Revised – Site Investigation and Conceptual Remedial Workplan

Site 1 (VCP Site 00615-2)

HHMT – Port Ivory Facility

Re: HHMT - Port Ivory Facility
Site 1, ID # V00615-2
Site Investigation/Remedial Action Work
Plan

Drawing Number **FIGURE 5**

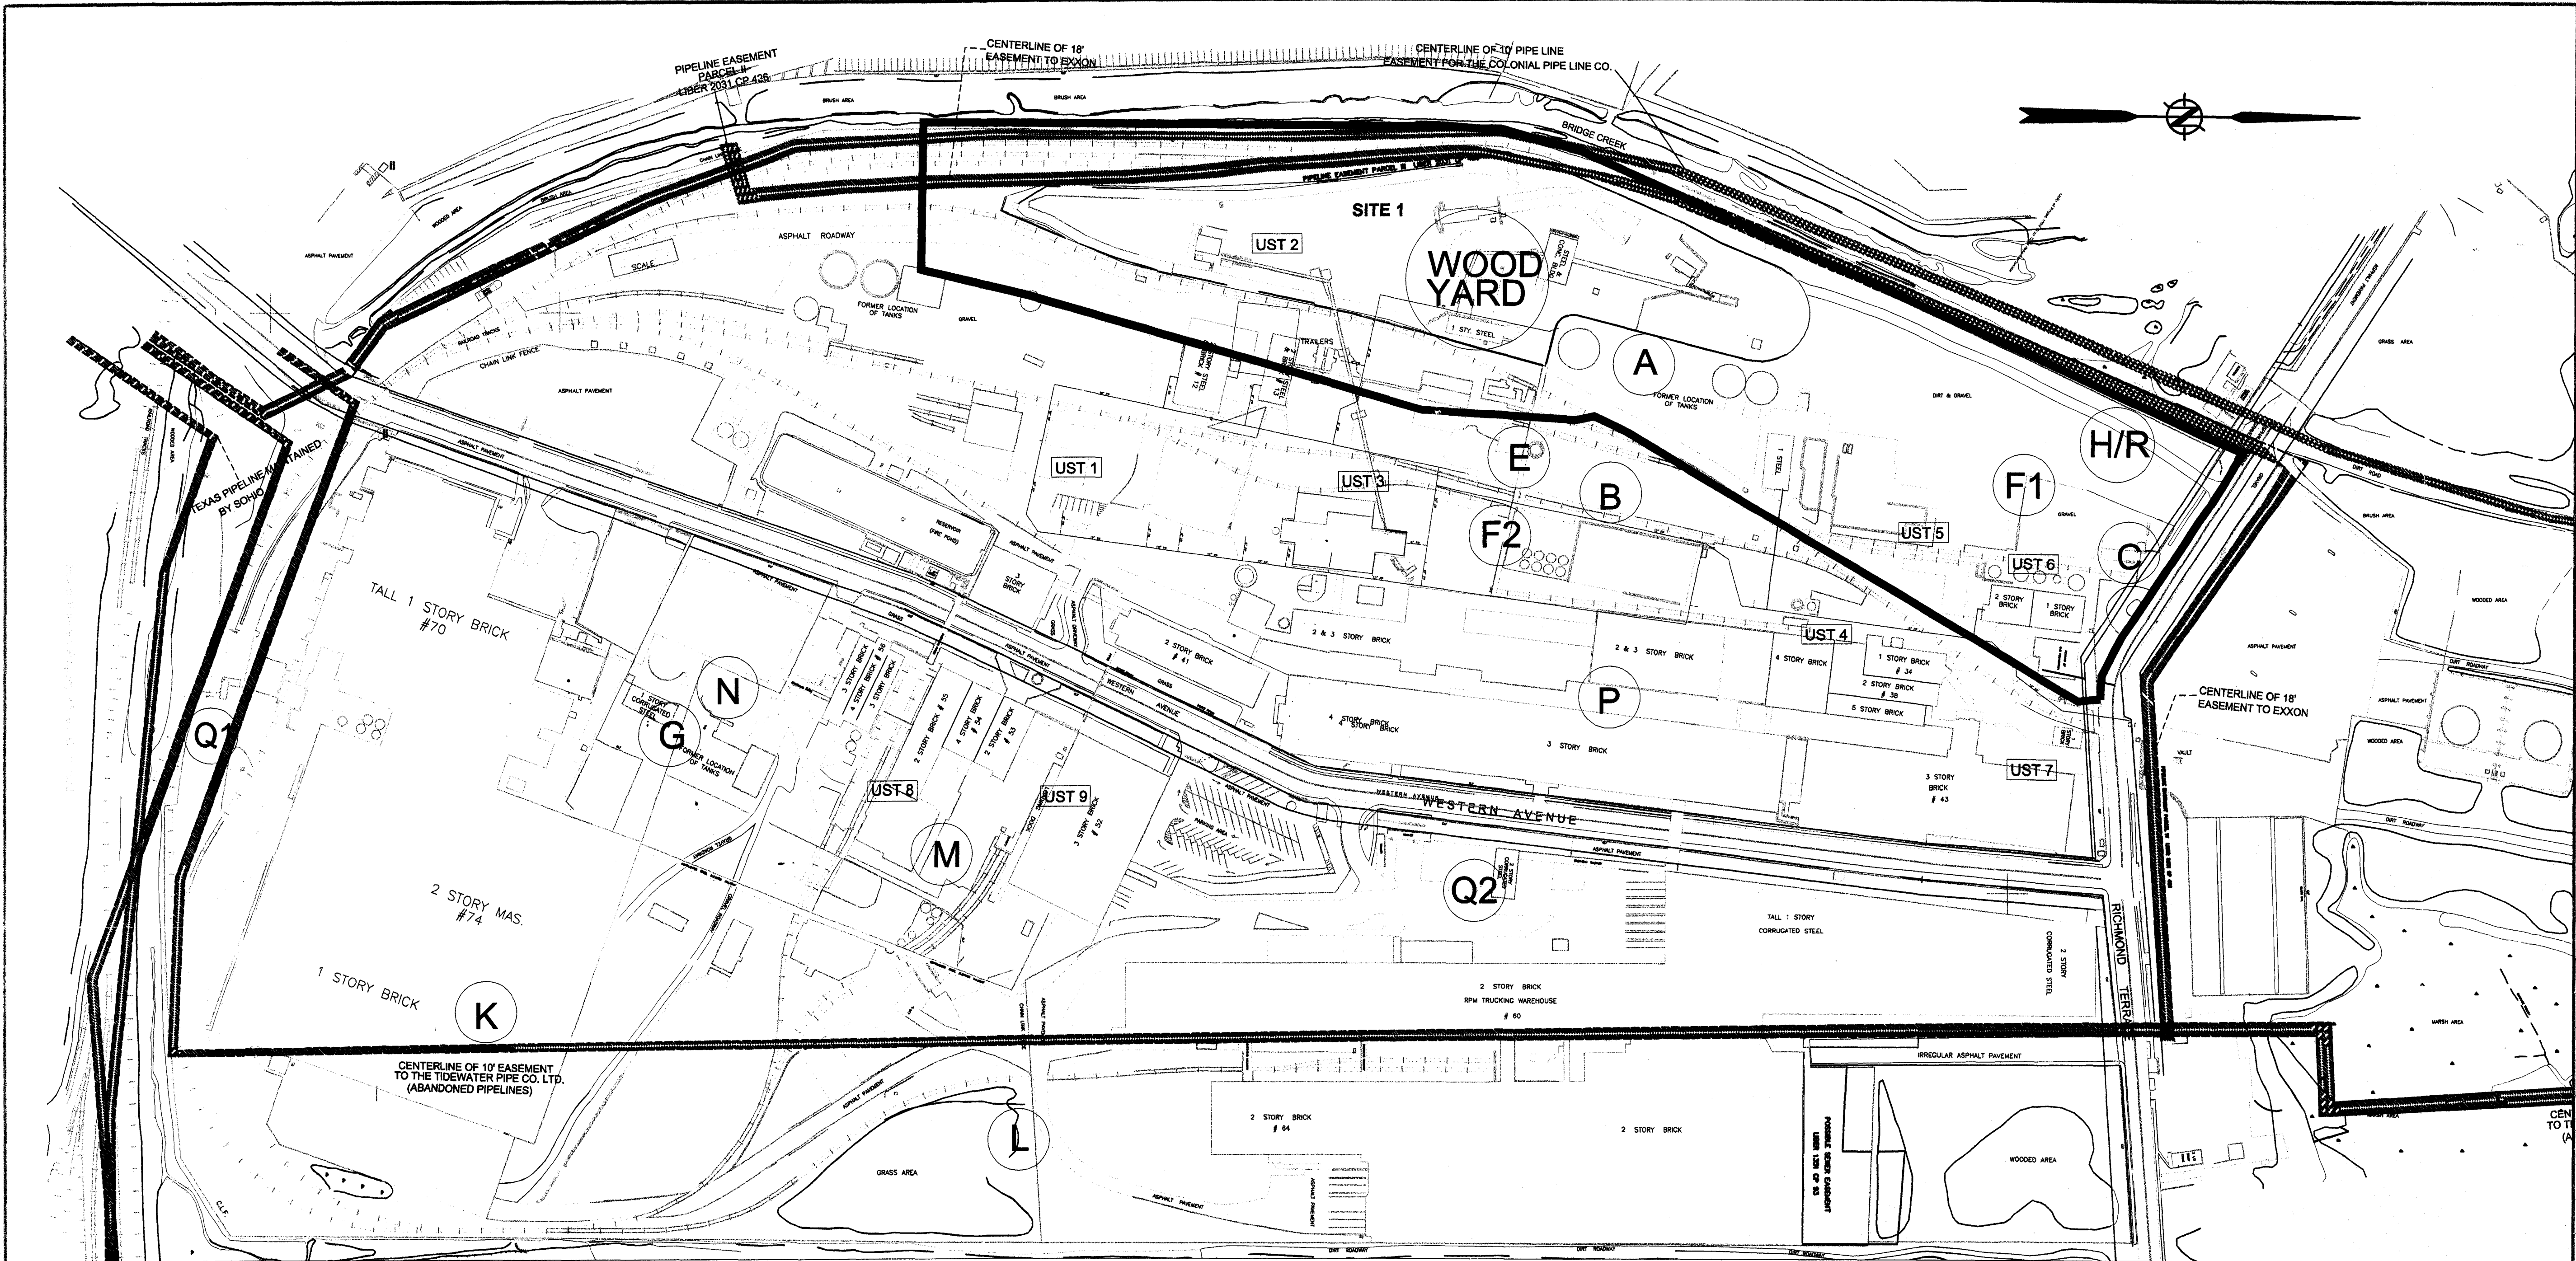
Page 30, Section 5.6 and Figure 5

ok In the second paragraph it states that three surface water samples were collected (SW-1, SW-2 and SW-3) yet Figure 5 identifies five surface water samples. Please resolve the discrepancy.
